Item Name: Crosstube Turning Detail

DART AEROSPACE LTD		Work Order:	102604
Description: Crosstube Assembly (412 Low Narrow Aft)		Part Number:	D412-664-245
Inspection Dwg: D412-664-245 Rev: D		Page 1 of 2

DRAWING NO. D412-664-245		TITLE CROSSTUBE ASS'Y (412 LOW-N AFT)		REV. D DART AEROSPACE LTD ENGINEERING ORDER		D.E.O. NO. D412-664-245-D-1		SHEET NO. SHEET 1 OF 2		SCALE NTS	
DRAWN <i>q</i>		CHECKED <i>SC</i>		MFG. APPR. <i>EC</i>		APPROVED <i>MP</i>		DE APPR. <i>#</i>			
DATE 11.05.25		DATE 11.05.31		DATE 11.05.31		DATE 11/05/31		DATE 11.05.31

DRAWING NO. D412-664-245	TITLE CROSSTUBE ASS'Y (412 LOW-N AFT)	REV. D	DART AEROSPACE LTD ENGINEERING ORDER		D.E.O. NO. D412-664-245-D-2	SHEET NO. SHEET 1 OF 1	SCALE NTS
DRAWN DP	CHECKED AS	MFG. APPR. E	APPROVED MP		DE APPR. H		
DATE 11.09.07	DATE 11.09.12	DATE 11.09.12	DATE 11.09.12		DATE 11.09.12

**D412-664-245
ASSEMBLY DETAIL**

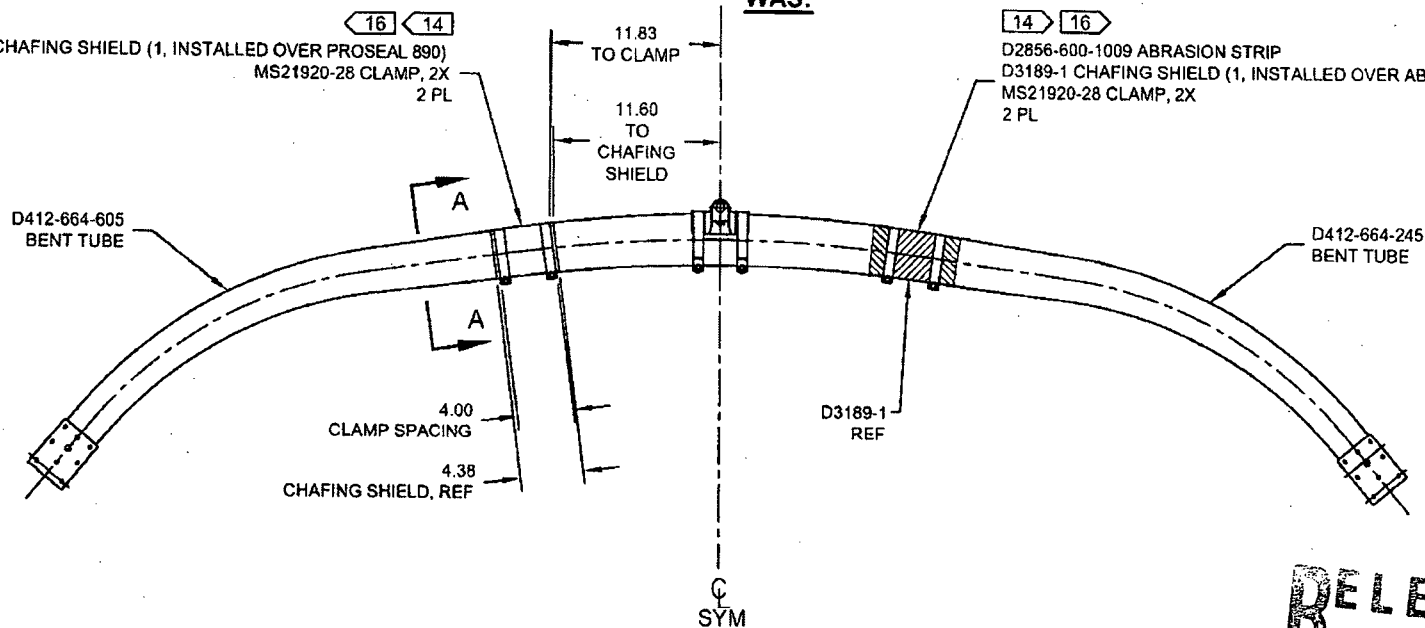
REMOVED ABRASION STRIP IN FAVOR OF A THIN LAYER OF PROSEAL 890. UPDATE INSTALLATION OF CHAFING SHIELDS AND REDUCE TORQUE TO 40-50 IN-LBS. THIS ENGINEERING ORDER SUPERCEDES DEO D412-664-245-D-1

IS:

D3189-1 CHAFING SHIELD (1, INSTALLED OVER PROSEAL 890)
MS21920-28 CLAMP, 2X
2 PL

WAS:

D2856-600-1009 ABRASION STRIP
D3189-1 CHAFING SHIELD (1, INSTALLED OVER ABRASION STRIP)
MS21920-28 CLAMP, 2X
2 PL

SECTION A-A
CHAFING SHIELD DETAIL
VIEW ROTATED, NOT TO SCALE

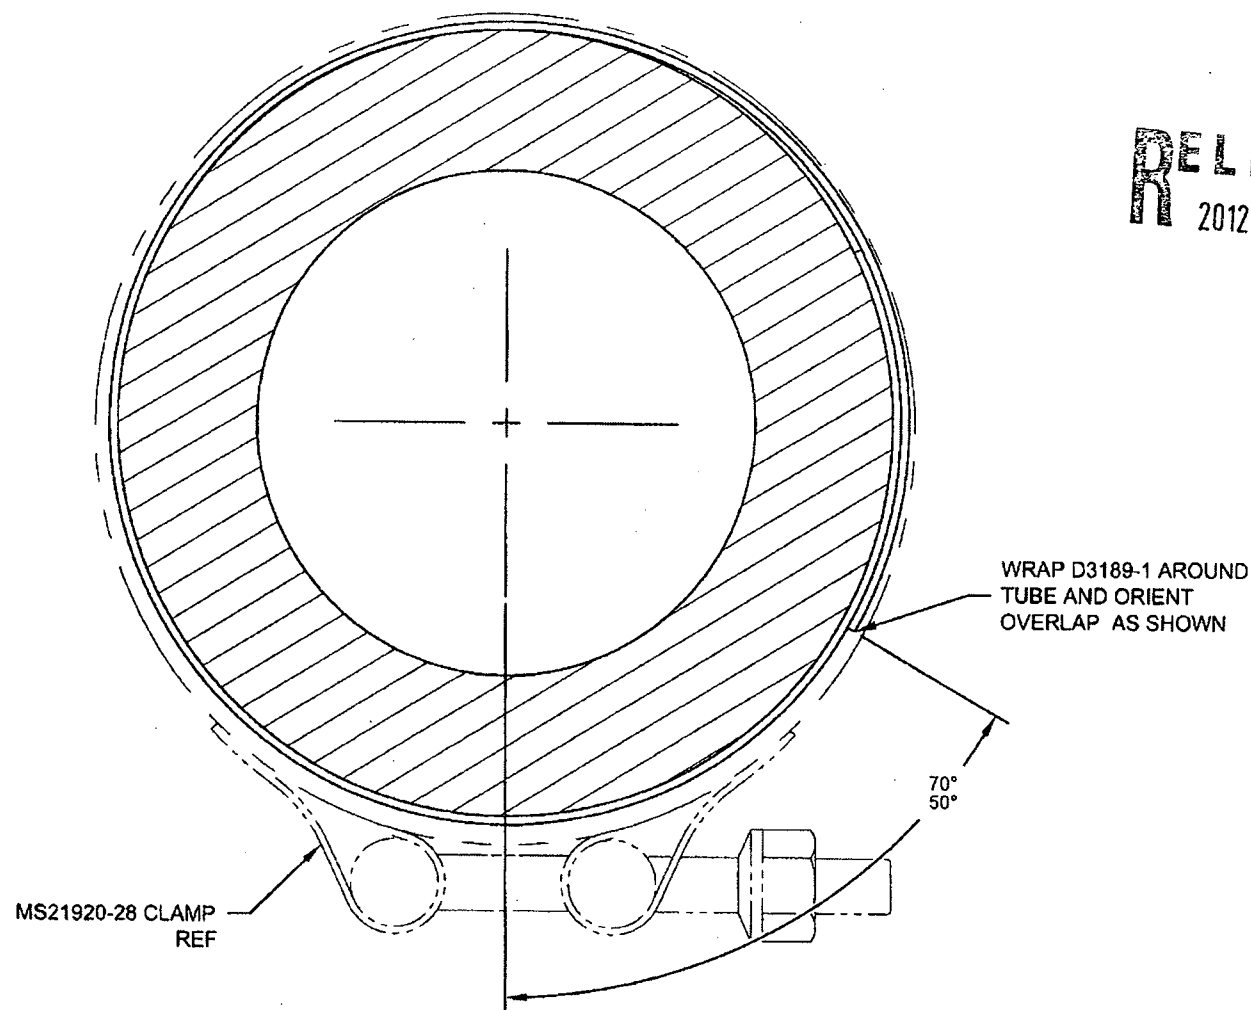
- 14) APPLY A THIN COAT OF PROSEAL 890 ON INSIDE CONCAVE SURFACE OF D3189-1 CHAFING SHIELD AND LET CURE PER MANUFACTURER'S INSTRUCTIONS. INSTALL PROSEALED D3189-1 CHAFING SHIELD ONTO CROSSTUBE BY APPLYING A THIN COAT OF PROSEAL 890 ONTO CROSSTUBE. BE SURE TO ELIMINATE ANY AIR GAPS.
- 16) TORQUE CLAMPS ON D2896-1 SUPPORT 80 TO 100 IN-LB. **TORQUE CLAMPS ON D3189-1 CHAFING SHIELD 40 TO 50 IN-LB.** ENSURE AT LEAST 1.5 THREADS SHOWING IN SAFETY AND THAT NUT HAS NOT BOTTOMED-OUT AFTER TORQUING.
